ADMINISTRATIVE AMENDMENT (PD) ADD2005-00177

ADMINISTRATIVE AMENDMENT LEE COUNTY, FLORIDA

WHEREAS, American Land Ventures, L.L.C., filed an application for administrative approval to a Mixed Use Planned Development on a project known as Coconut Point MPD - Area #3 - Tract 3D **to**:

POINT CONCEPT **EXHIBIT** MASTER COCONUT

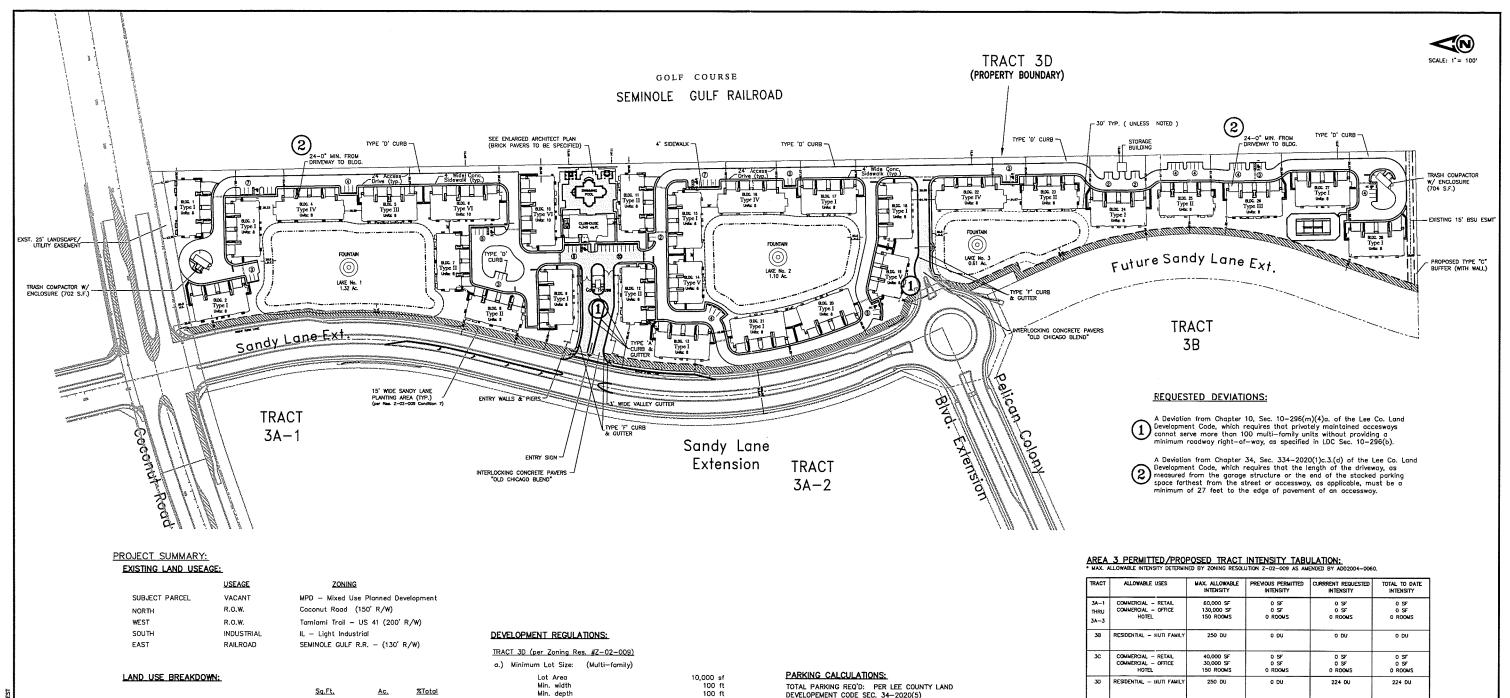
- 1. The only changes approved as part of this administrative amendment are as follows:
 - a. reconfigure the lakes in Area #3; and
 - b. reconfigure Tracts 3A-2, 3-A3, 3B, and 3C; and
 - c. add a deviation seeking relief from LDC Section 10-296(m)(4)a. which requires that privately maintained accessways may not serve more than 100 multiple family units without providing a minimum road right-of-way as specified by LDC Section 10-296(b); to allow the design of the project as proposed in Area 3 Tract 3D as shown on the attached Plan; and
 - d. add a deviation seeking relief from LDC Section 34-2020(1)c.3.(d) which requires the length of the driveway, as measured from the garage structure or the end of the stacked parking space farthest from the street or accessway, as applicable, must be a minimum of 27 feet to the edge of pavement of the accessway; to allow 24 feet.

- 2. The Development must be in compliance with the amended Master Concept Plan (stamped received on August 23, 2005) and Master Development Plan for Coconut Point Area 3 - Tract 3D (stamped received on August 23, 2005). The only authorized changes to the original Master Concept Plan (as amended) are described on Condition 1 above. Master Concept Plan for ADD2005-00177 is hereby APPROVED and adopted. A reduced copy is attached hereto.

ATTACHMENT C VISIBILITY EXHIBIT

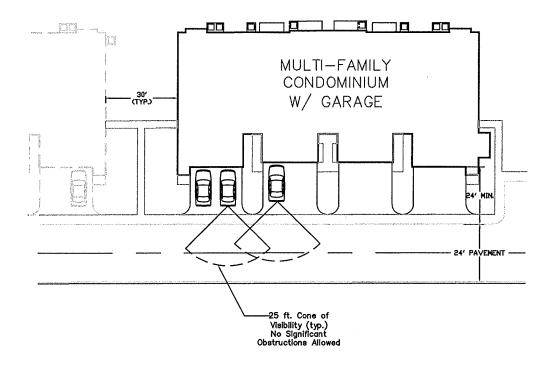
- A deviation seeking relief from LDC Section 34-2020(1)c.3.(d) which requires the 4. length of the driveway, as measured from the garage structure or the end of the stacked parking space farthest from the street or accessway, as applicable, must be a minimum of 27 feet to the edge of pavement of the accessway; to allow 24 feet, is APPROVED subject to the condition that the design is substantially in compliance with Attachment C, Additional Support for Deviation #2 and the development order plans must show nothing (landscaping, signage, structures, etc.) that will impede sight distance.

Additional Support for Deviation #2 from Section 34—2020(1)c.3.(d)
